Job Ref: 17013, RMA200204

Central Hawke's Bay District Council  
Private Bag 9002  
Hastings 4156

## **RMA200204 – Response to Section 92 Further information Request**

**Figure 2:** Noise assessment – TukiTuki River environment, Earcon, Memo, dated 4<sup>th</sup> March 2021

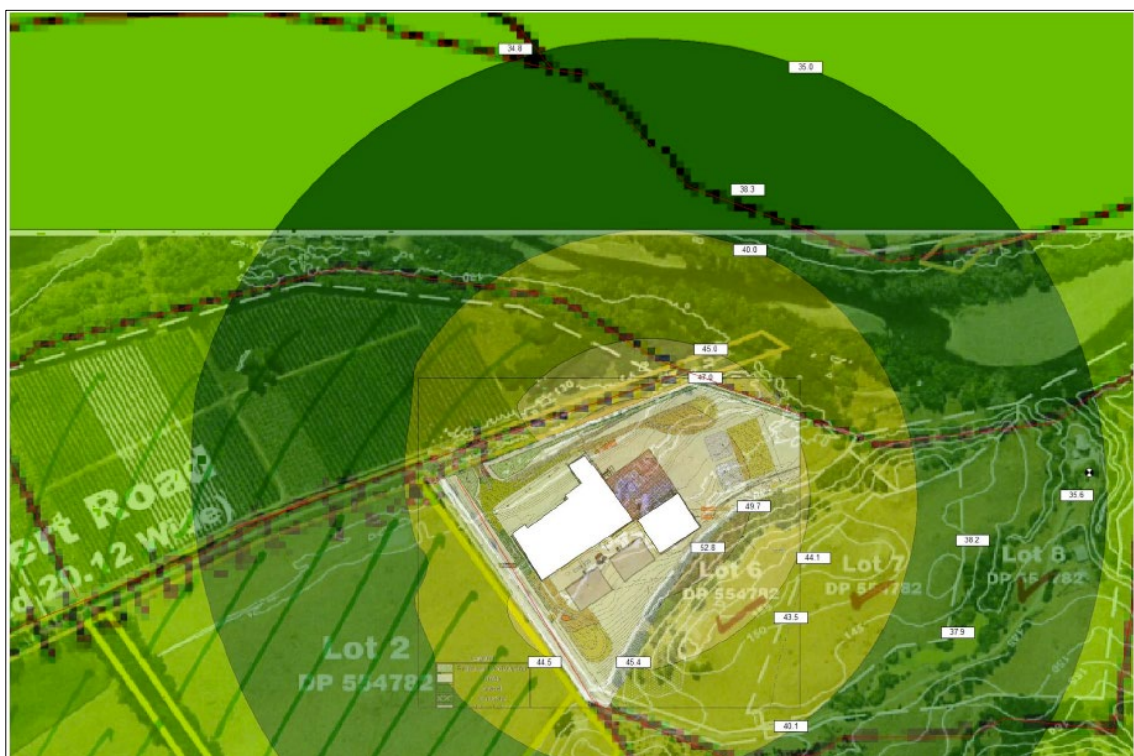
- d. Although there are no notional boundaries within the nearby Tukituki River pathway and reserve, please provide comment on the potential noise effects on users of those recreational areas.

(d) The nearby Tukituki River pathway and reserve,

The noise assessment has calculated the noise limits within the immediately adjoining area of the Tukituki River and esplanade and this is shown in **Figure 2**. The Figure shows concentric noise limits out from the proposed compost production activity. At the boundary of the river esplanade, there is a small area that reaches between 45 – 47 dBA, and beyond this area the noise is 40- 40dBA in the majority of the modelled area. This noise levels modelled demonstrate the expected noise is well under the daytime (55dBA) limit, and a small area shall exceed the night time time by 2dBA. The night time limit is applicable to Sunday's. Sundays will not typically have the loaders or conveyer system operating. The applicant anticipates the occasional Sunday where the working yard and Mixing Hall are to be used (8 times per year), so noise up to the 47dBA can be expected on those Sunday's.

Given the area of noise non-compliance is relatively small, the degree of non-compliance is marginal, the times this non-compliance would occur is low, the effects are considered to be less than minor on the Tukituki River, being part of the wider environment.

**Figure 3<sup>8</sup>:** Rural Zone Noise Limits, compliance applied to the new subdivisions within the broader farm owned by TMM (existing and future) houses.

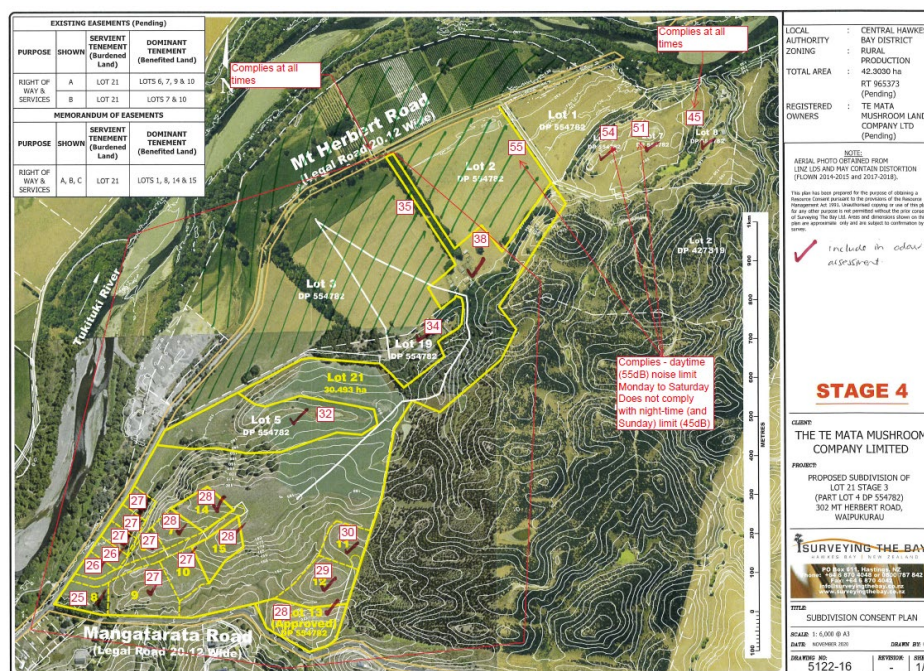
- e. Please provide comment on the potential for new dwellings, and therefore new notional boundaries, to create future difficulties in complying with the District Plan noise limits, including on the closest properties on the opposite side of the Tukituki River and on the consented but unimplemented new lots created by the subdivisions listed in item 1(g) above.

(e) Consented but unimplemented new lots created by the subdivisions within broader TMM Farm

The noise assessment is also updated to show the noise compliance limits within the subject site and wider farm property with respect to the proposed new lots both consented (Stage 1, 2 and 4) and currently being processed (Stage 3) and this is depicted in **Figure 3**. Lots 6 and 7 DP 554782 are immediately south-west of the proposed composting facility. The noise is expected to comply with the daytime noise limits at Lot 6, Lot 7 and Lot 2. Yet, the noise levels are not expected to comply with the night time (11pm – 6am Monday – Saturday, and All day Sunday) noise limits. The applicant intends to ensure these titles have consent notices securing a set of 'no complaint' clauses to protect the proposed compost production facility, and to also make future owners aware of the environment that they are buying into.

Lot 2 DP 554782 is situated to the east of the proposed compost facility, beyond the existing driveway to the rear of 464 Mt Herbert Road. This property is not for residential development, and this restriction was stipulated in the subdivision consent (RM190134). The noise levels at the closest boundary of Lot 2 DP 554782 do not comply with the nighttime noise, yet as this property (paddock) is to remain without a sensitive residential development on it, as such, the potential adverse noise effects are considered to be less than minor. This property shall have a 'no complaints' consent notice registered on the title, same as Lot 6 and 7.

All other new lots within the subject site and wider farm property comply with the Rural Zone noise limits.
